SUBJECT: TMI ACTION ITEM II.K.3.30

Davis-Besse Nuclear Power Station
Unit No. 1

SAFETY EVALUATION REPORT
FOR THE
BABCOCK AND WILCOX OWNERS GROUP
SMALL BREAK LOSS-OF-COOLANT ACCIDENT
EVALUATION MODEL, CRAFT2 (REV. 3)
(BAW-10092P, REV. 3 AND BAW-10154)

Figure 2. Comparison of CRAFT2 to RELAP5. RELAP5/MOD2 sensitivity study on percentage of steam generator tubes wetted by AFW.

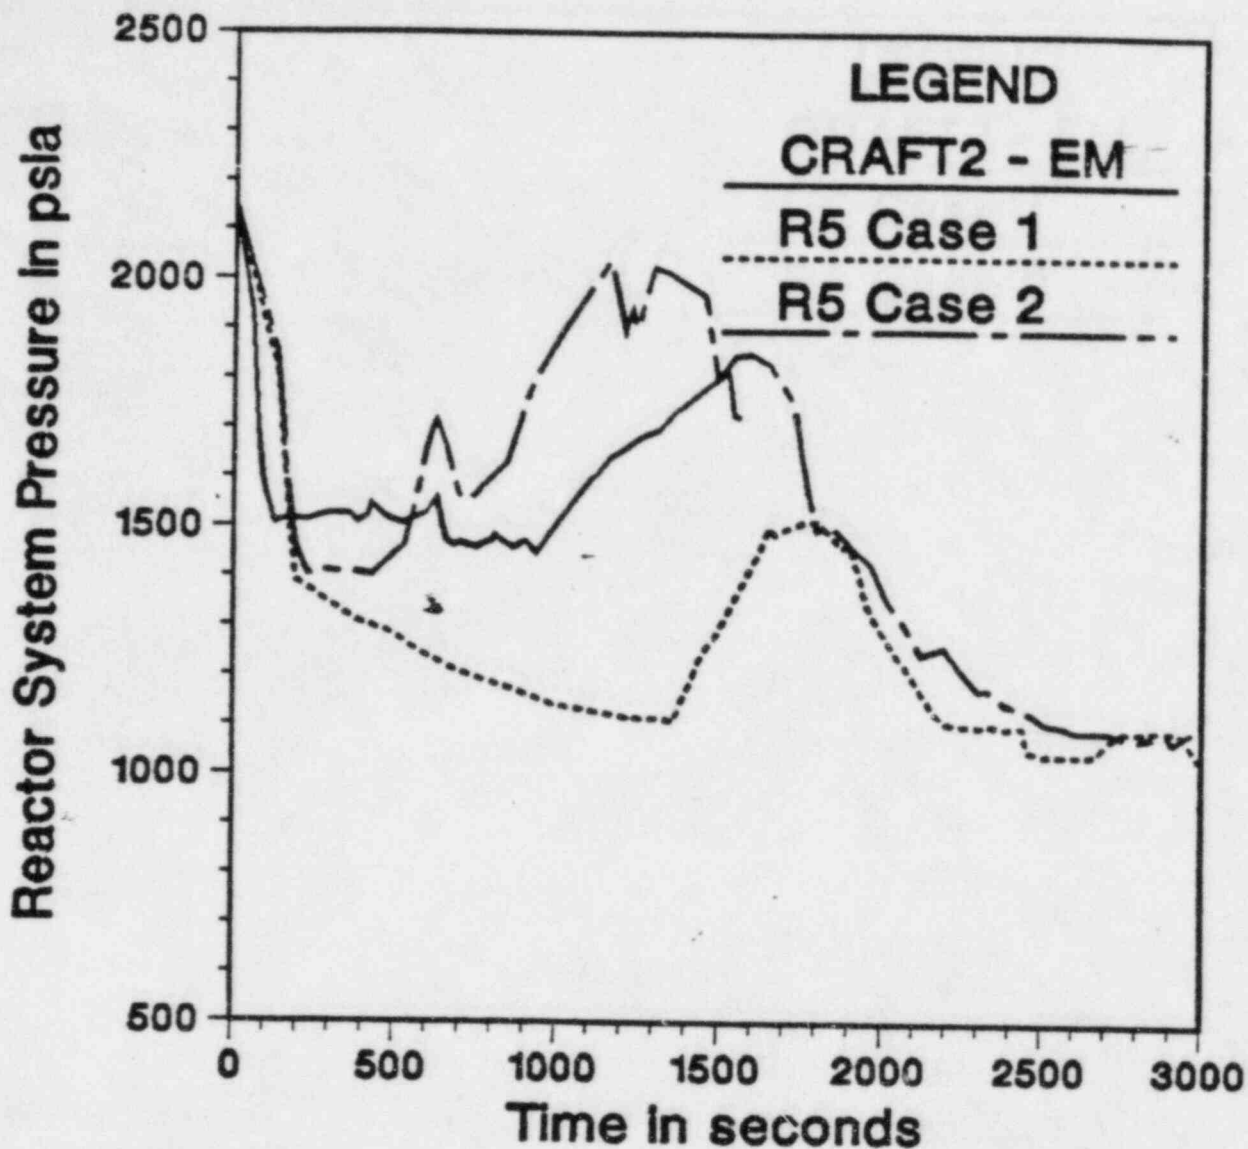
Recently completed analyses performed by the NRC with the RELAP5/MOD2 computer program have been qualitatively compared to the B&W CRAFT2 results for a 0.01 square foot cold-leg break (Reference 15). While this study was not intended to be a direct audit analysis, input assumptions were selected to explore the effects of natural circulation, reactor system repressurization, and boiler-condenser heat transfer including the effectiveness of Auxiliary Feedwater (AFW) spray on the upper OTSG tube elevations.

The RELAP5/MOD2 analyses indicated that although AFW wetting effectiveness can influence the primary system response, the general trends are unaffected. The analyses demonstrate that repressurization can occur during a small break LOCA at a B&W lowered-loop plant. Figure 2 provides a comparison of the RELAP5 results to a similar CRAFT2 analysis. This confirms the B&W CRAFT2 results for a similar size break. The timing of the operator action to raise the secondary system water level to 95% was found not to be critical. Some boiler-condenser heat transfer was found to occur with the level at 50% of the operating range, which terminated the increase in the reactor system pressure before the level was raised to 95%. Finally none of the conditions examined led to core uncover or heat-up.
